16 April 2025

Re: Outline application for Land at Colwell Farm Lewes Road under reference DM/25/0445

Chart 1: Traffic volumes on Lewes Road (5 day average)

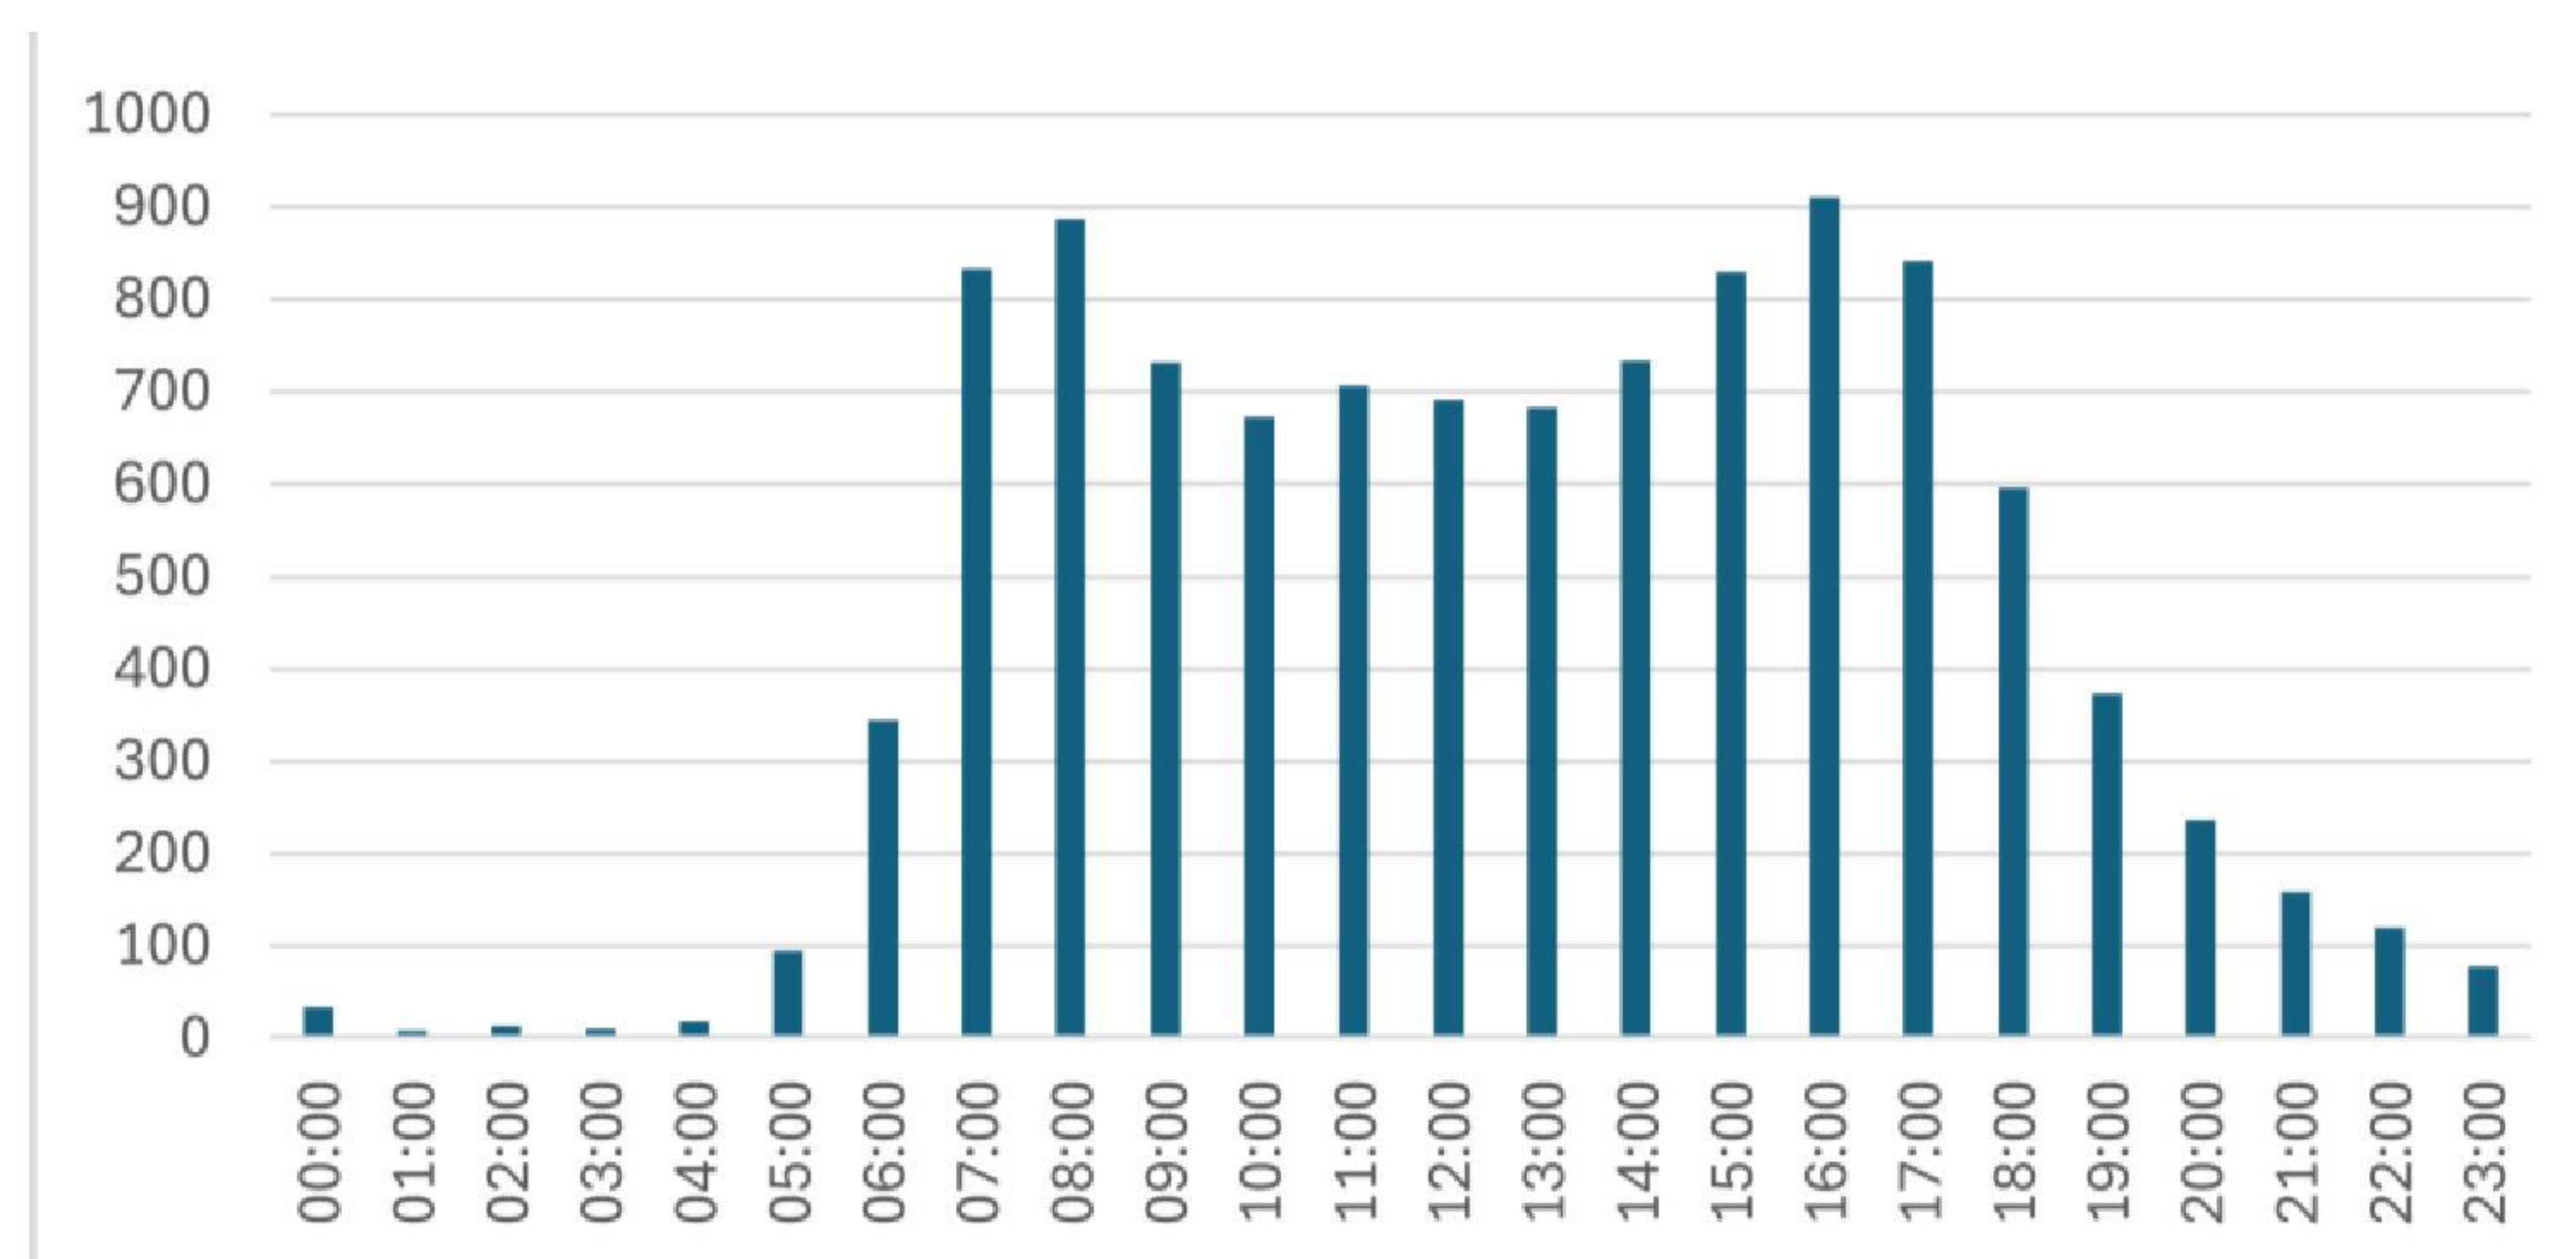
WSCC traffic volume data indicates that peak usage hours of A272 is over a more prolonged period than considered by Millers Homes. Between 07:00 and 18:00, the road is heavily used – not just for the peak hours of 08:00 – 09:00 and 17:00 – 18:00, considered by Millers Homes. Trip Impact should be considered for this extended period.

The cumulative impact of 80 homes on the road network needs to be considered over the extended peak period of 07:00 – 18:00 (not just the 2 one-hour “peak periods” considered).
